August 23, 2018

Re: KBUR Proposed SID Procedures OROSZ THREE and SLAPP THREE

The City of Los Angeles ("City") provides these comments in response to the Federal Aviation Administration's ("FAA") request for comments on the above-referenced proposed OROSZ THREE and SLAPP THREE RNAV procedures.

Historic Resources within 5 Miles of TEAGN

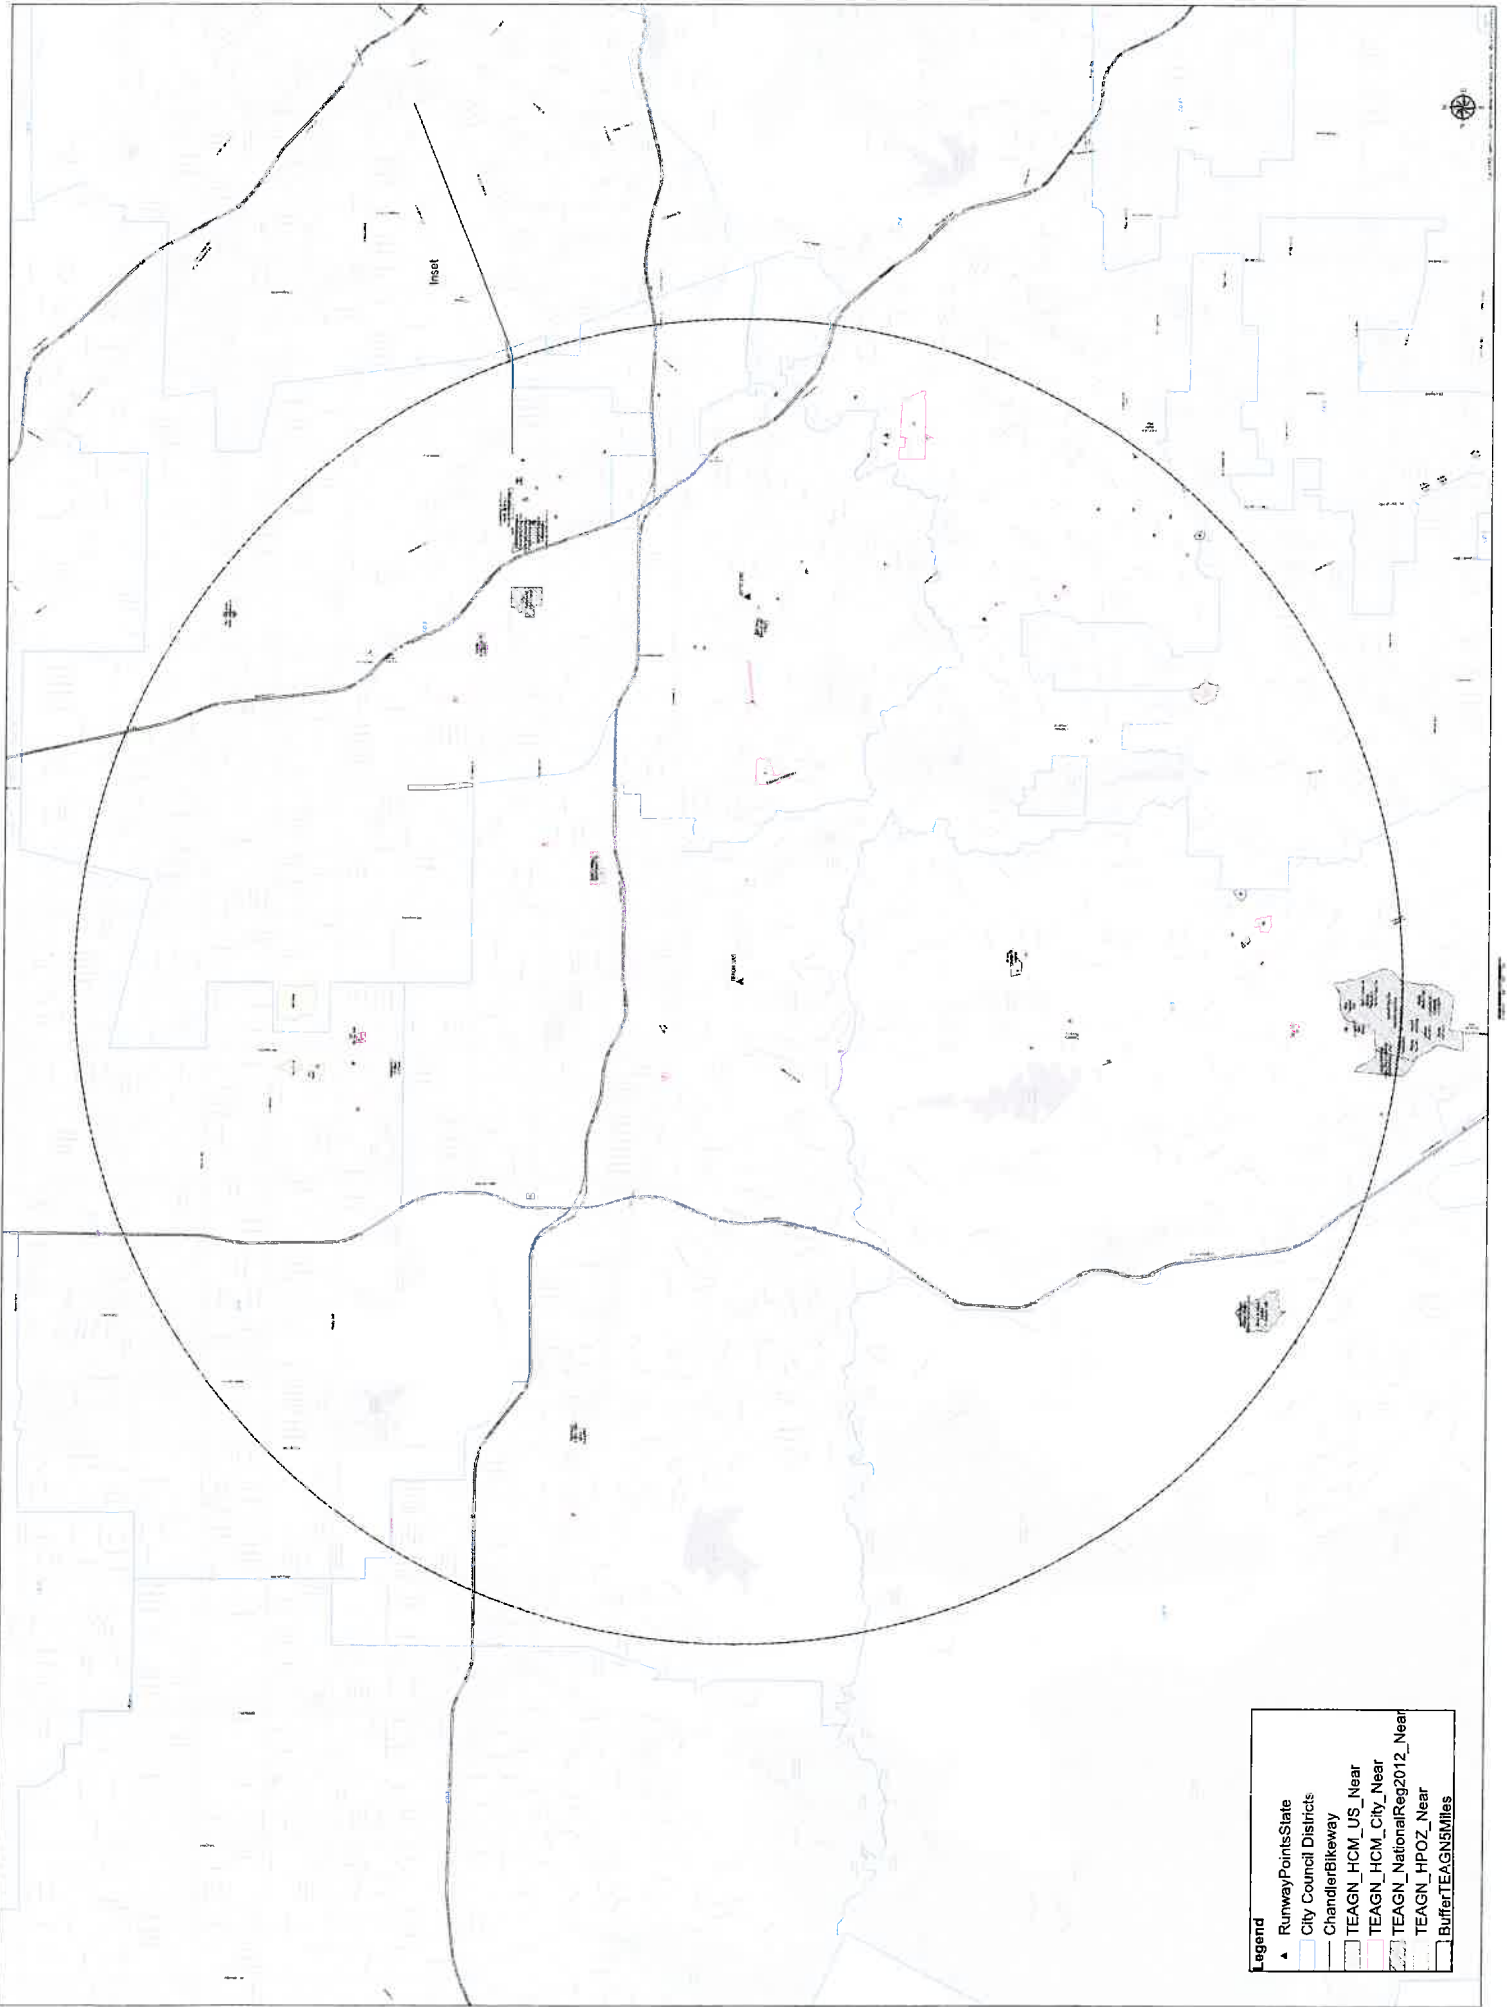
1. An impact on cultural resources protected under the National Historic Preservation Act, including the historic properties located under or near the proposed routes identified in Attachment 1 to these comments. See FAA Order 1050.1F ¶ 5-2(b)(1).
